NEW CASTLE SUBDIVISION

The purpose of this application is to subdivide a metes and bounds parcel into 78 lots.

APPLICATION NUMBER 12 DATE July 1, 2004

DETAIL SITE PLAN

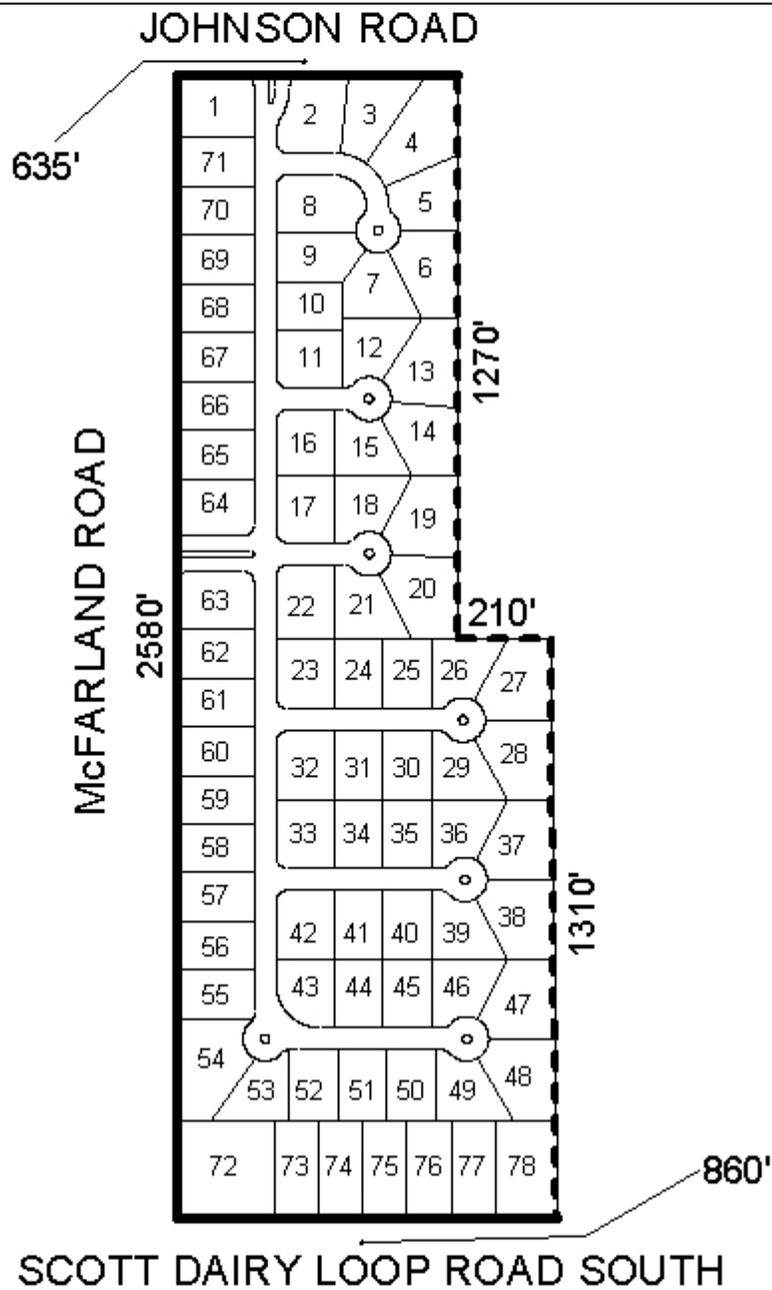
Scott Dairy Loop Road South, which has an existing right-of-way of 60-feet, is shown as a major street on the Major Street Plan, and as such requires a 100-foot right-of-way; therefore, the dedication of sufficient right-of-way to provide 50-feet from the centerline should be required. It should be noted that the applicant has this street labeled as Dawes Lake Road on the preliminary plat; however, Dawes Lake Road changes names at the intersection of Dawes Road.

As proposed, Lots 1-4 and 54-72 would front both Johnson Road or McFarland Road and the new streets. In order to provide proper access management along the minor and major streets, the placement of a note on the final plat stating the Lots 1-4 are denied direct access to Johnson Road, Lots 54-71 are denied direct access to McFarland Road and Lot 72 is limited to one curb cut, with the size, location and design to be approved by County Engineering, should be required.

As illustrated on the plat, the applicant is providing landscaped areas at the street entrances and in the cul-de-sacs; therefore, these areas should be labeled as common area and a note placed on the final plat stating that the maintenance thereof is the responsibility of the property owners.

The 25-foot minimum building setback lines are not shown but would be required on the final plat.

This site is located in the County, thus a note should be placed on the final plat stating that any lots which are developed commercially, and adjoin residentially developed property, must provide a buffer, in compliance with Section V.A.7. of the Subdivision Regulations.

The plat meets the minimum requirements of the Subdivision Regulations and is recommended for Tentative Approval subject to the following conditions: 1) the dedication of sufficient right-of-way to provide 50-feet from the centerline of Scott Dairy Loop Road South; 2) the placement of a note on the final plat stating the Lots 1-4 are denied direct access to Johnson Road, Lots 54-71 are denied direct access to McFarland Road and Lot 72 is limited to one curb cut, with the size, location and design to be approved by County Engineering; 3) that the landscaped areas be labeled as common area and a note placed on the final plat stating that the maintenance thereof is the responsibility of the property owners; 4) the placement of the 25-foot minimum building setback lines on the final plat; and 5) the placement of a note on the final plat stating any lots which are developed commercially, and adjoin residentially developed property must provide a buffer, in compliance with Section V.A.7. of the Subdivision Regulations.
